कार्यालय : वन संरक्षक, प्रादेशिक अंचल, हजारीबाग

विषय :- गोन्दलपारा कोल खनन परियोजना हेतु 219.80 हे0 वनभूमि अपयोजन प्रस्ताव (FP/JH/MIN/139492/2021) के संबंध में।

S.N	Query by MoEF&CC	Reply by User Agency	DFO Comments	CF Comments
1	As per the Para 7.8 of the Chapter-7 given in the Consolidated Handbook of Guidelines and Clarification issued under the Van (Sanrakshan Evam Samvardhan) Rules-2023, a justification behind opening new mining lease in the region shall be submitted along with a brief profile of the lessee/company, giving details of their existing mining leases in the State with their capacity of production, the present level of average annual production, location of these pits and the status of reclamation of forest land are exhausted minerals etc. The State Government is requested to submit the justification accordingly.	The Gondulpara Opencast Coal Mine in North Karanpura coal fields in Hazaribagh district of Jharkhand State has been allocated to M/s Adani Enterprises Limited (AEL) vide vesting order no: NA-104/10/2020-NA dated 8 th March 2021 by Ministry of Coal, Government of India. As per the approved mining plan, the target production capacity is 4.0 MTPA. A total of

Figure 5: Map showing the mining stage beyond which further progress is not possible without an external dump.

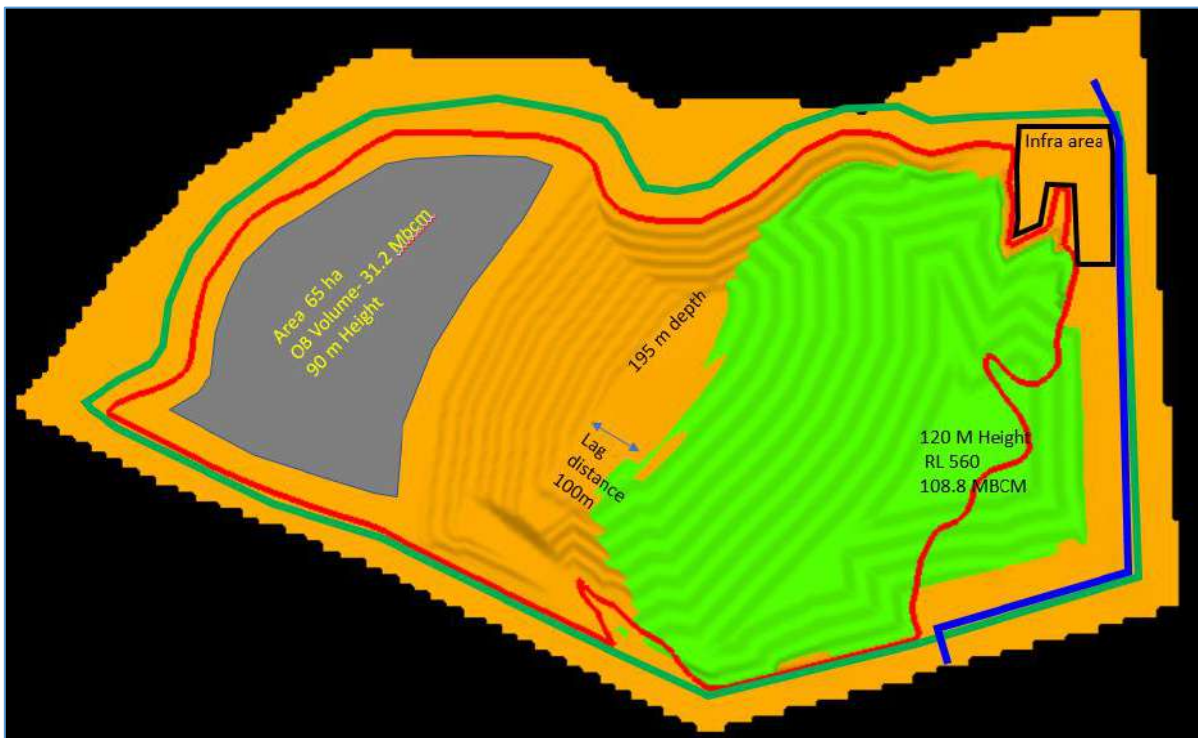
<p>Point 5</p>	<p>Out of the total 219.8 ha of forest land involved, an area of 65.23 ha has been earmarked for an external overburden (OB) dump located outside the mine block, and 24.59 ha has been earmarked for an OB dump within the mine block. The State Government shall provide detailed justification for the proposed use of forest land for a non-site-specific activity such as the external OB dump. Considering the presence of villages and non-forest land in the vicinity of the mining lease area, the State Government shall also clarify why the OB dumping cannot be carried out on nearby non-forest land, instead of diverting additional forest land for this purpose.</p>
<p>Reply</p>	<p>The requirement for an external OB dump arises due to the large volume of overburden (approximately 279.47 Mm³) generated during mining operations. While 229.27 Mm³ can be accommodated within the mine block, the remaining 50.20 Mm³ cannot be managed internally without sterilizing significant coal reserves and compromising mine safety. IIT Kharagpur's technical study (Attached as Annexure 2) confirms that rehandling within the block would reduce coal recovery from 70.21% to 45.13%, resulting in a loss of about 41 MT of coal and shortening the mine life from 32 years to 20 years which makes the project non-viable.</p> <p>The block and surrounding features are given in the figure below on the next page:</p>

For the scenario when an external dump is not considered, the point beyond which the reserve will be sterilized is shown in Figure 5. In Figure 5, the dump is 315 m high (195 m + 120 m), and benches are 30 m tall. Compliance with all relevant regulations lead to an overall dump slope angle (crest-to-toe) of 23.7° (Figure 6). The impact on coal extraction reserves for the scenario involving an external OB dump, as well as for the rehandling options without an external dump, is summarized in the Table 6. Without external OB dump area ~ 41.18 Mt of reserve will be sterilized, and the percentage of extraction/recovery will reduce from 70.21% to 45.13%.

Figure 11: Reclamation plan at the end of mining life.

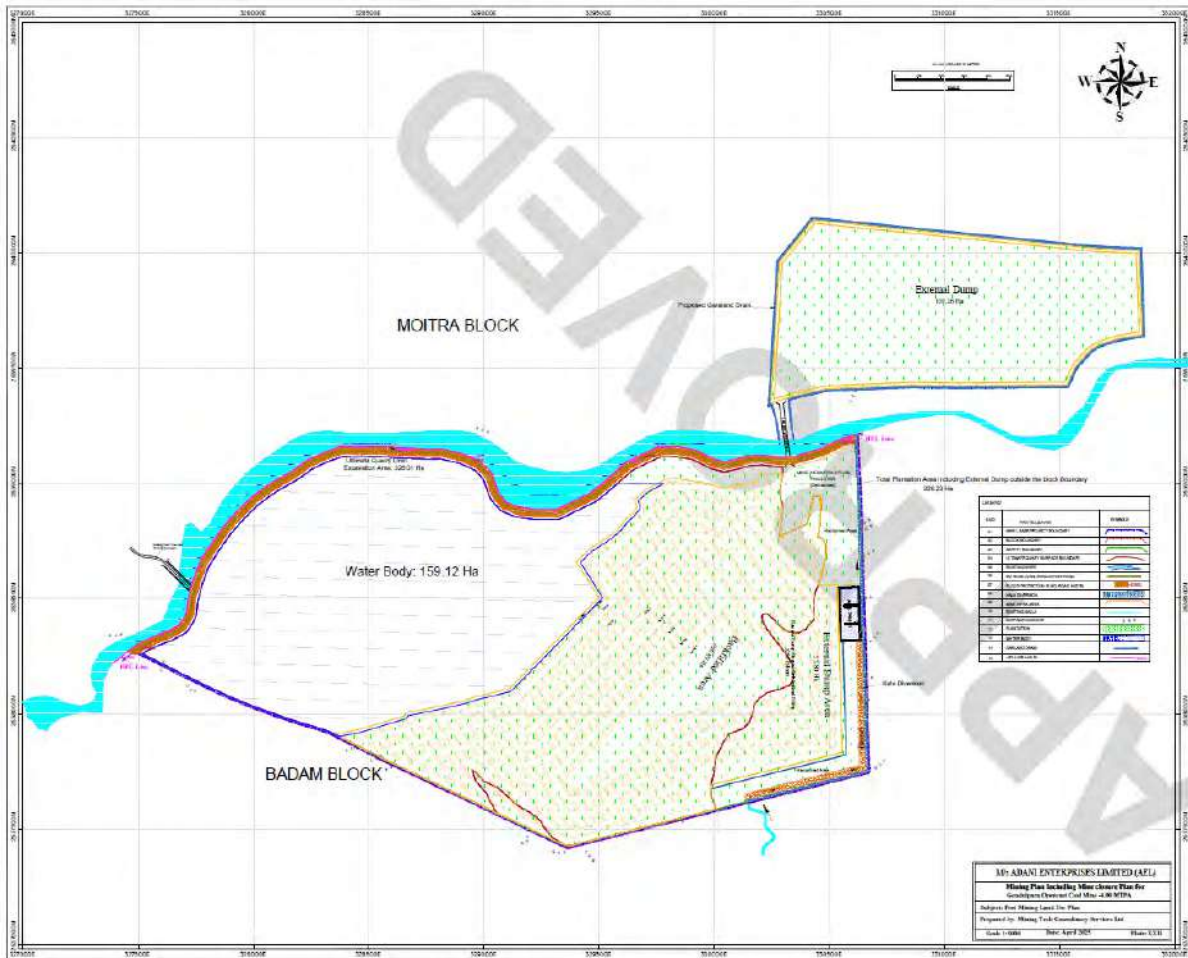
<p>Point 4</p>	<p>In the land use details at the end of mine life, it has been mentioned that 159.12 ha area will be kept as void. Keeping in view the huge quantity of Over Burden proposed to be generated, the state shall give the justification to not backfill the mined-out area at the end of mine life.</p>
<p>Reply</p>	<p>The Gondulpara Opencast Coal Mine has a planned operational life of 32 years, during which approximately 279.47 million cubic meters (MBCM) of overburden (OB) will be generated. Of this, 229.27 MBCM will be accommodated within the vested block area, while the remaining 50.20 MBCM will be temporarily stored in an external OB dump outside the block.</p> <p>Out of total 279.47 MBCM OB to be handled during the mine life, around 106 MBCM volume will be placed above the Original Ground Level (OGL) out of this around 50.20 MBCM has been placed as external Dump outside of block area. This external dump will be fully rehandled at the end of the mine life and utilized for backfilling the mined-out void to restore the area close to its Original Ground Level (OGL).</p> <p>The remaining OB left above the OGL is approx. 56 MBCM will be part of internal dump. Since the life of Mine is 32 years and plantation in internal dump cannot be done till the dump reaches the final planned elevation, which happens only after the 7th year.</p> <p>After the 7th year, biological reclamation will start and will progressively continue till the end of mine life. By the end of mine life, some of the plantation done on the internal OB dump will be more than 25 years old. If we were supposed to handle this 56 MBCM OB above OGL to fill the void, it would result in complete destruction of mature vegetation which is neither environmentally desirable nor operationally justified. This restricts further filling of void area.</p> <p>The quarry is planned for mining up to maximum depth of 300 meters. Thus, with complete rehandling of OB placed on external OB dump outside the block; and ensuring no destruction of vegetation done on the internal OB dump, a residual void is left out which will be converted into a shallow body (less than 30 meters depth), serving dual objectives:</p> <ul style="list-style-type: none"> • Water resource augmentation in a water-scarce region. • Socio-economic benefits through fisheries and related livelihood opportunities.

A comprehensive reclamation plan is in place: the external dump will be rehandled at the end of mine life and brought back to original level to backfill the voids, followed by afforestation, ensuring restoration of the diverted forest land.

As per the approved mining plan, the proposed external OB dump will be rehandled at the end of the mine life to backfill the excavated voids (refer Annexure A). This will restore the external dump area close to its original ground level. Following reclamation and plantation, the forest land will be handed back to the concerned authority (Figure 11).
